#### Addendum #1 to IFB #081662017 Burnham Boiler Replacement McHenry County College

## MCHENRY COUNTY COLLEGE **BURNHAM BOILER** REPLACEMENT

MECHANICAL **NEW WORK ROOF PLAN**

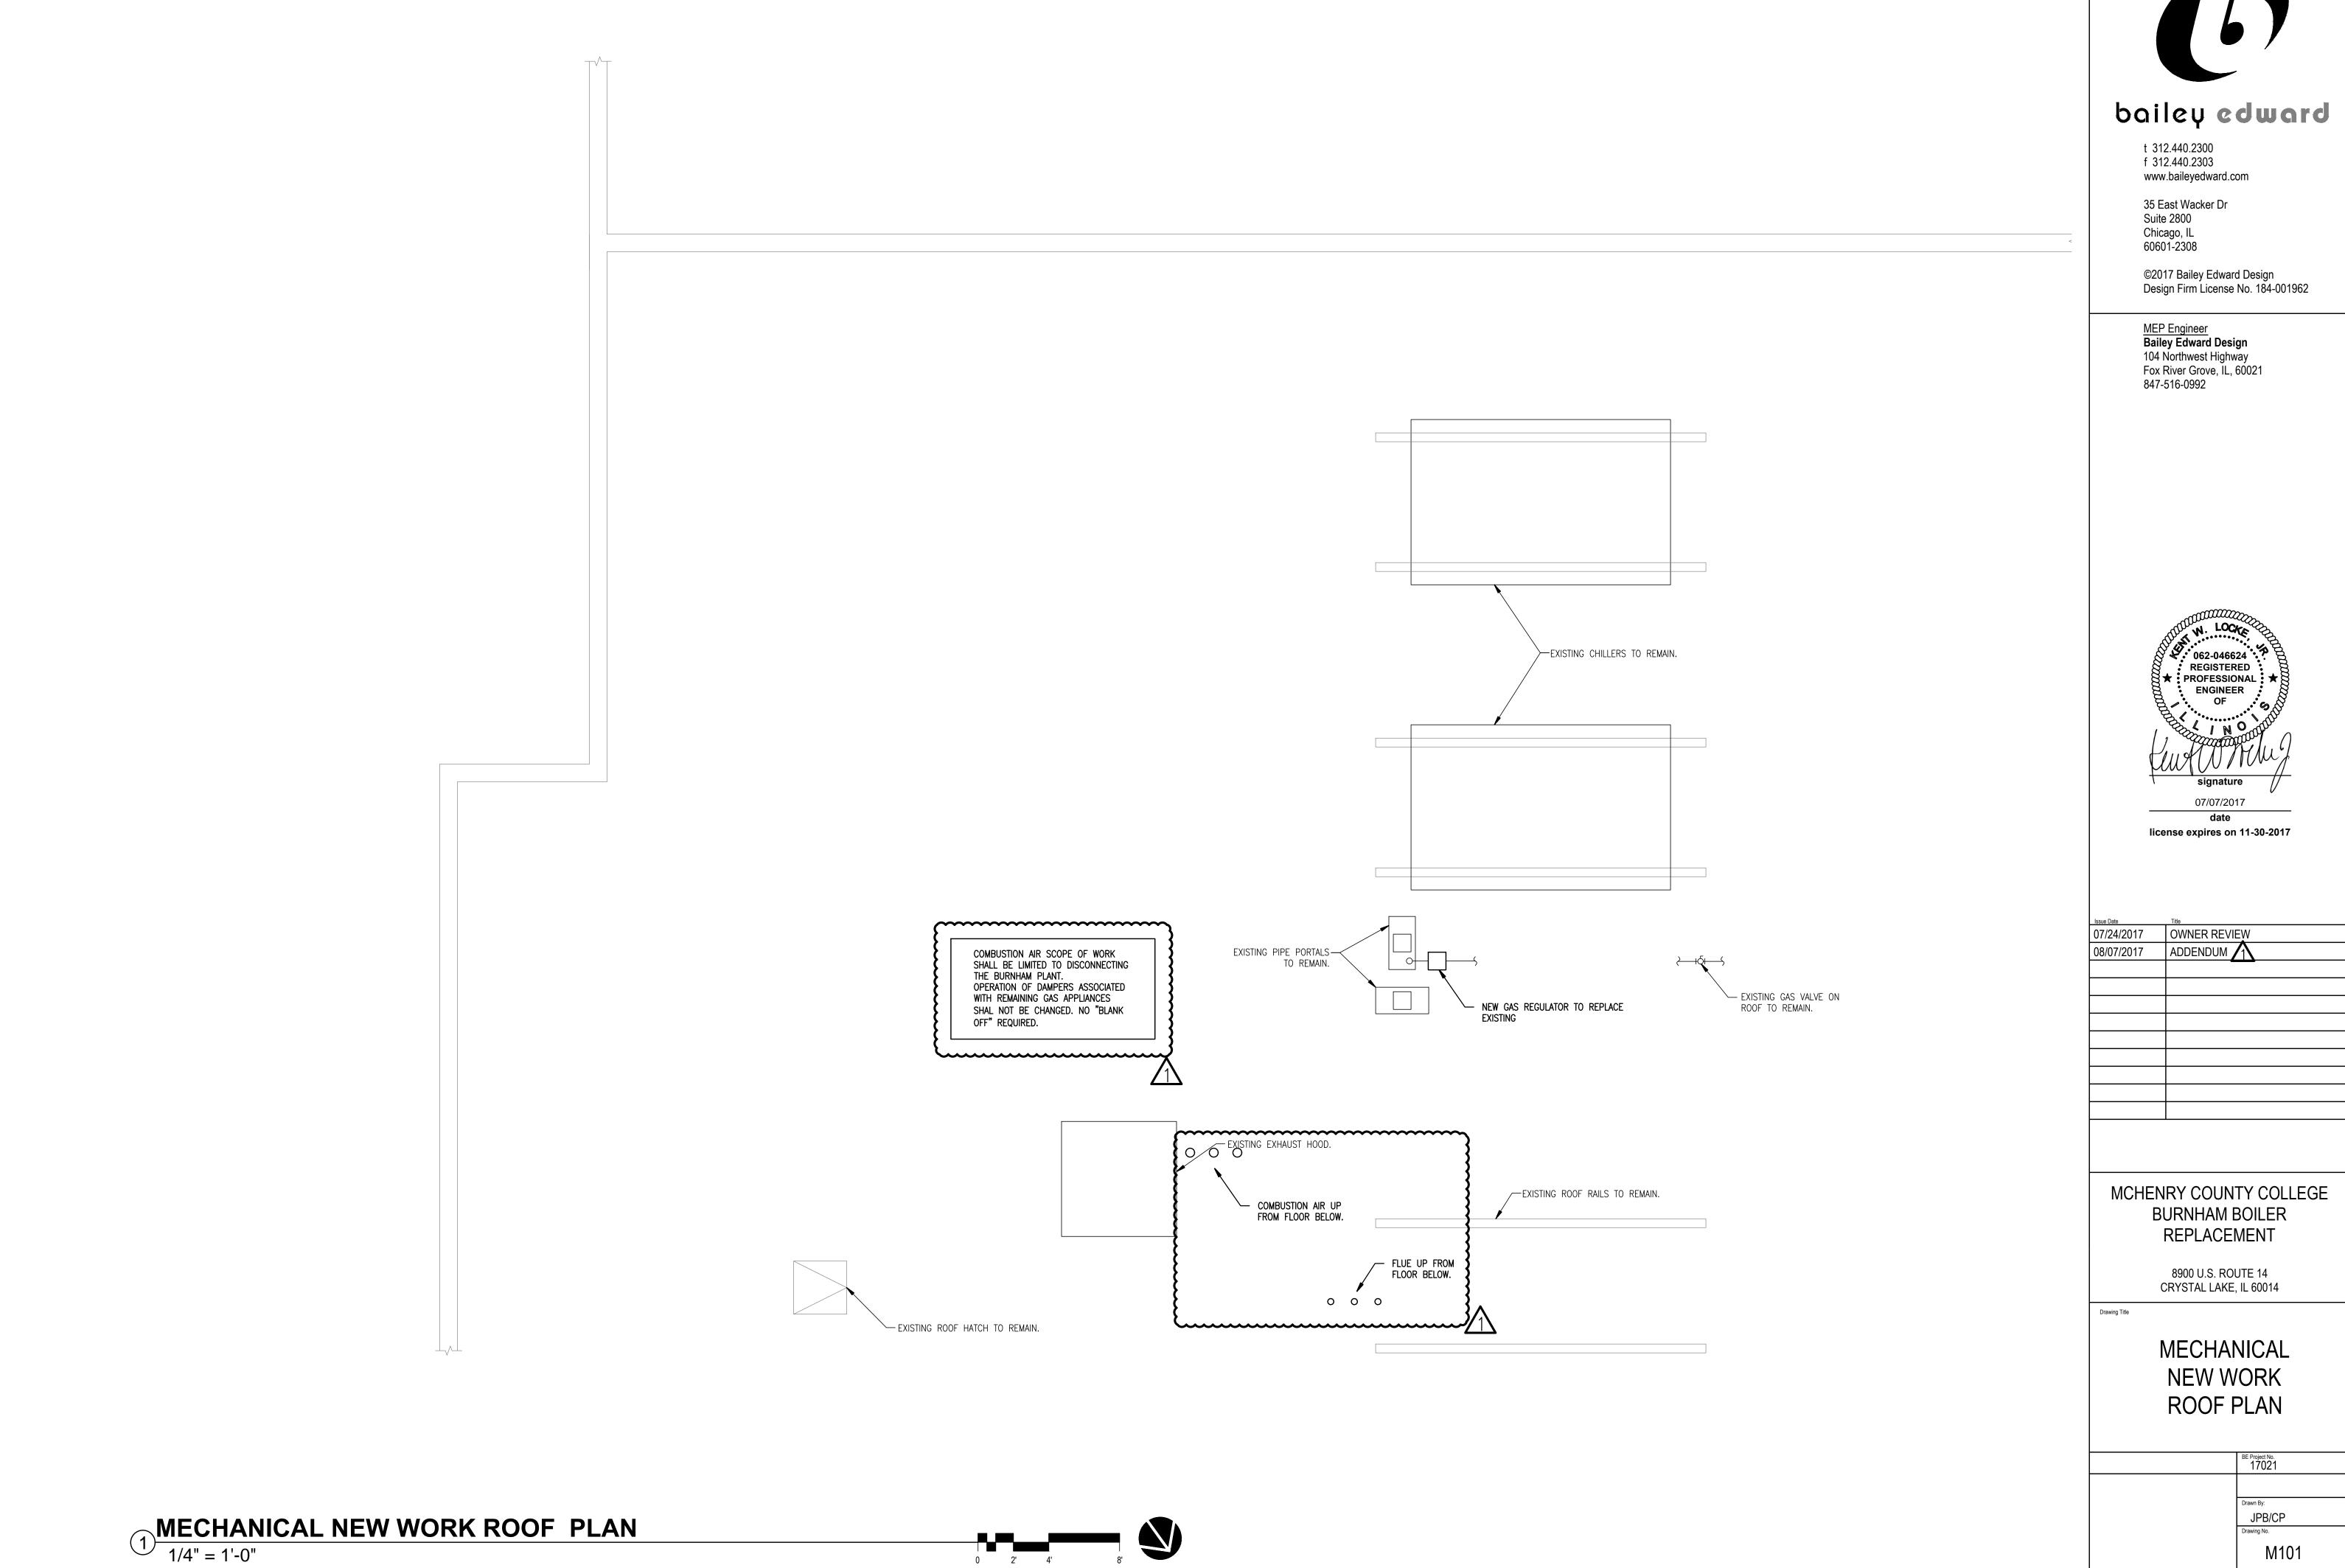
- d. Who is the current chemical water treatment company/contractor? HOH Water Technology out of Palatine, Alex is our tech.
  - e. Are the existing combustion air opening(s) to be "blanked-off" to accommodate the new "high efficiency" boilers? No, because we still need combustion air for other boilers in the area. (See item f below.) Now noted on revised plan.

- f. Are there any other gas fired appliances in the same room as the boilers that will utilize the combustion air? If so, what are the BTU input of each appliance? No. The new boilers are to each have a dedicated combustion air intake from the roof for each new boiler. See item #6 on page 7 of the print set. Noted on revised plan. (There are 4 other boilers in the room, but they are a different system entirely and utilize combustion air from existing combustion air dampers.)
